Potential Participants – Public Tender 14/2025 – for Planning, Design, Engineering and Consulting Services for Marine Structures and Auxiliary Facilities as Part of the Marina Development at Reading

Subject: Notice No. 3 in Public Tender 14/2025 – Answers to Clarification Questions

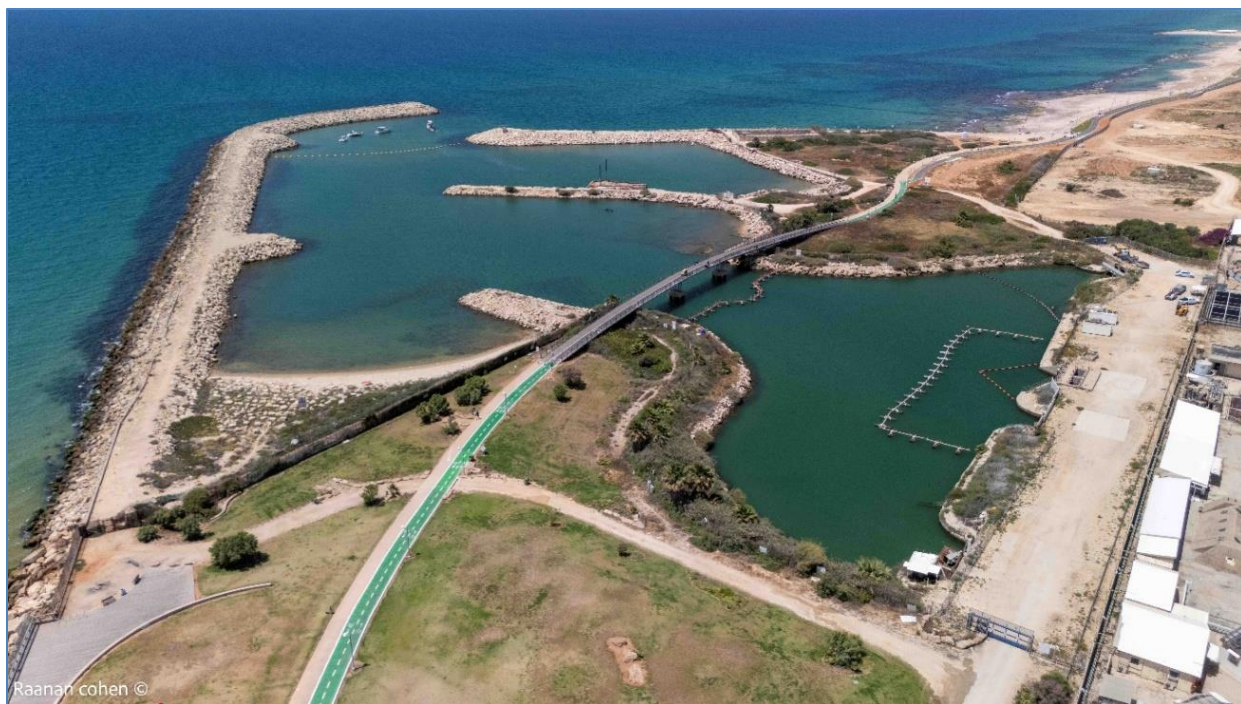
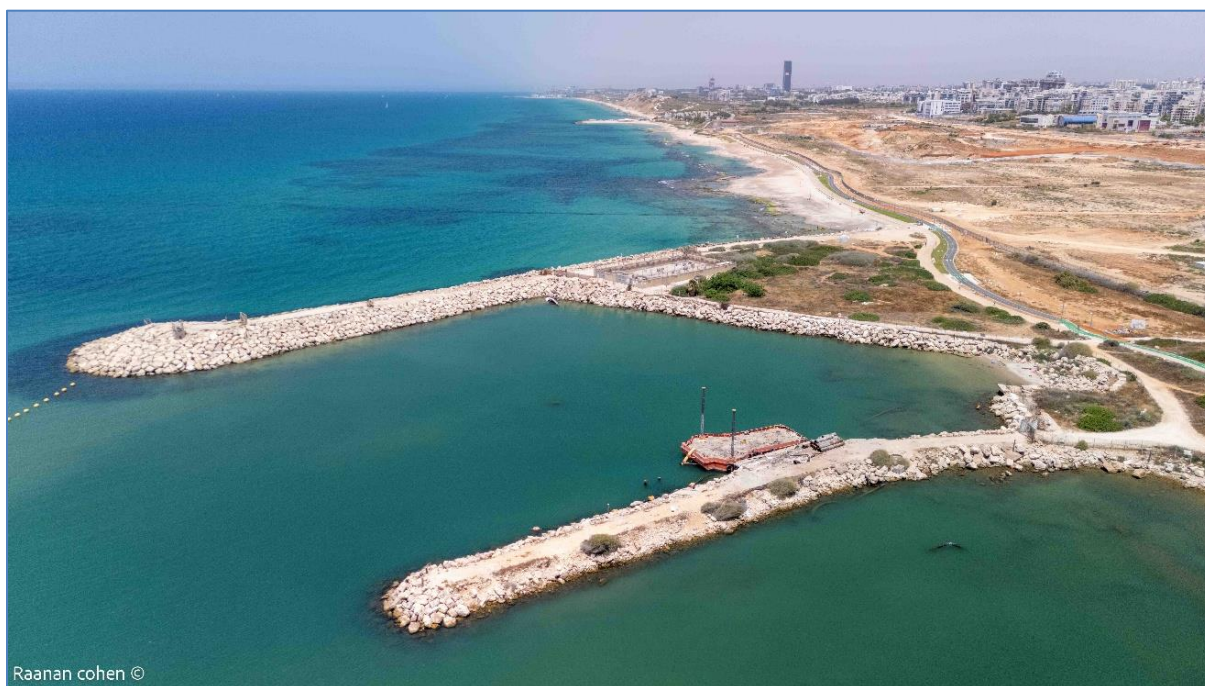
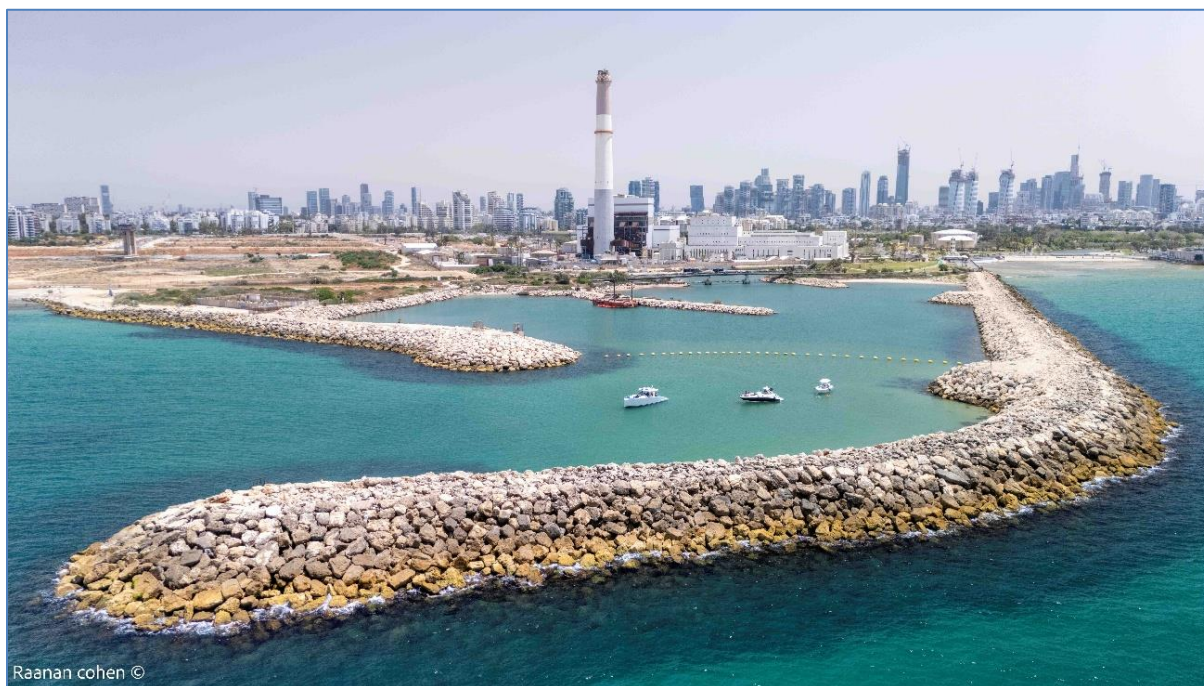
106.	Section 5-Scope of Work-Figures 2, 3, 4, 5 and 6	Figures 2, 3 and 6 appear to show a cove in the southeastern part of site, possibly with some beach nourishment. Please clarify what is existing and what if anything is to be designed by the selected consultant.	<p>1) Please see aerial views dated May 2025 showing the existing situation (scroll down to the end of this document).</p> <p>2) The cove represents a quay for sports activities. The marine component is part of the SOW.</p> <p>3) Figures 2, 5 and 6 in the SOW are screenshots. For clarification, the entire presentations (in Hebrew) are uploaded as PDFs on the Atarim website in the folder: "SUPPLEMENTS to Annex 9.1 – Reference Documents (1)".</p>

107.	Section 5-Scope of Work-Figures 2, 3, 4, 5 and 6	Several different colors are shown on these figures but there is no legend. Please add a legend and clarify what is	1) Please see aerial views dated May 2025 showing the existing

No.	Ref. Clause	Question	Answer
		existing and what is intended as new and is part of the selected consultant's work.	situation (<i>scroll down to the end of this document</i>). 2) Regarding the legends (in Hebrew): see Answer 3) to Question No. 106 above. 3) Parts of the legends are translated from Hebrew into English and are attached herewith as appendices (<i>scroll down to the end of this document</i>).
